Project: Blacktown Residential Project

Drawing Title: HEIGHTS COMPARISON

Drawing No: A610

Attachment 9

1 Heights CompariSon
1 : 100

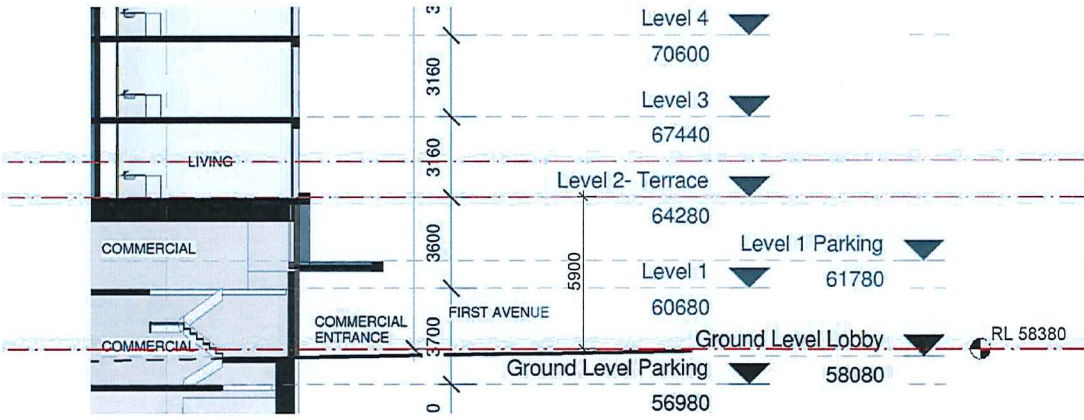
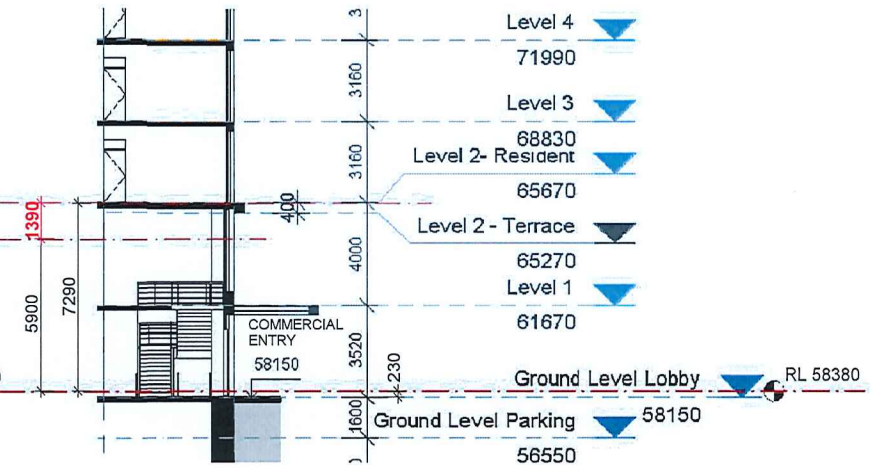
Ground floor business/retail tenancies are located approximately 1 metre lower than the adjacent footpath. The dropped floor level results in a poorly designed base for the building.

The 2 storey podium (i.e. the base of the building) has been increased in height by 1.39 m. This has been achieved by "lifting" the building so that it is no longer lower than the adjacent footpath.
